**BRUNSWICK-TOPSHAM BRIDGE
DESIGN ADVISORY COMMITTEE**

**PRELIMINARY
REPORT
on
DESIGN
RECOMMENDATIONS**

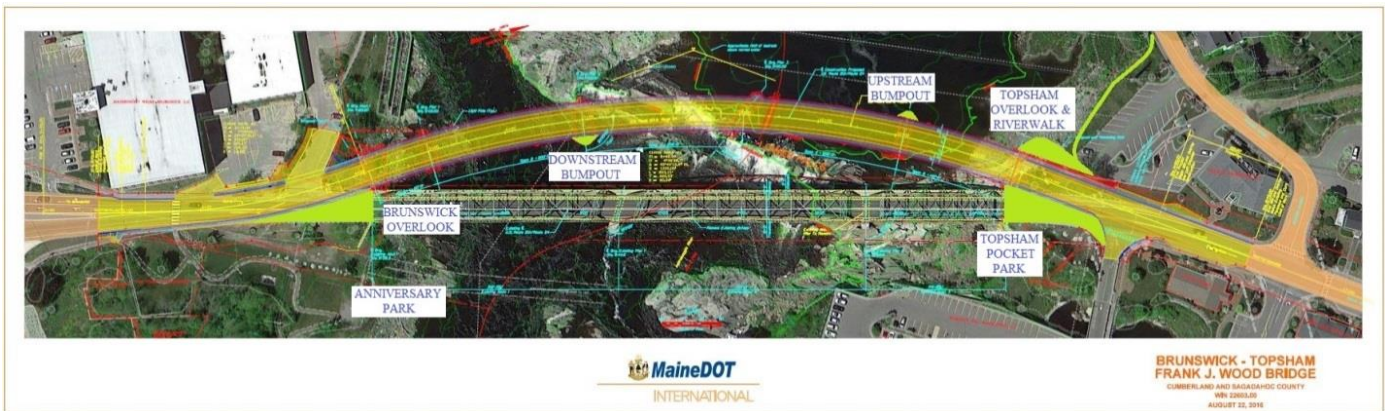
- There should be sidewalks on both sides of the bridge. Walkers should no longer need to cross Main/e Street at both ends of the bridge, which today can be dangerous, especially for people who are the elderly, disabled, or accompanied by small children.
- There should be safe and adequate bicycle lanes on both sides of the bridge.
- We recommend the width of the bridge should be allocated as follows (see image 1.1 Bridge Cross Section):
 - Two 11-foot motor vehicle lanes,
 - Two 5-foot shoulder/bikeways, and
 - Two 6'-4" sidewalks.

2.2 Rendering of wall/railing showing with lamp posts and arch-shaped insets

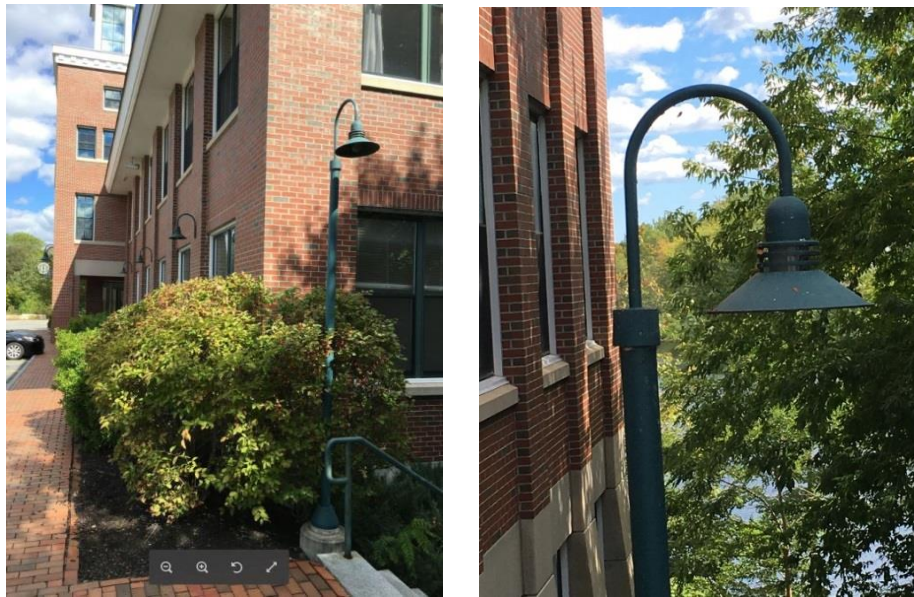
After much discussion and review of numerous rail types, the DAC drew inspiration from a bridge in a village in Vermont (see image 2.1 below) and suggests that the rail instead be a solid concrete lower portion with arch insets, a metal rail upper, concrete posts with pedestal lampposts incorporated within them at the appropriate spacing. This

wall/railing will pass crash standards, will complement area architecture, screens headlights, makes the bridge feel more like a bridge for pedestrians, allows the curve theme to continue with arch insets like the piers, and is aesthetically more pleasing.

The DAC recommends the bridge lamp posts shown in image 2.2, above. They reflect the area examples, are simple, promote the curve theme, and their black color will match lamps in both Brunswick and Topsham. These posts should be outfitted with flagpole hardware to allow the display of flags or banners.
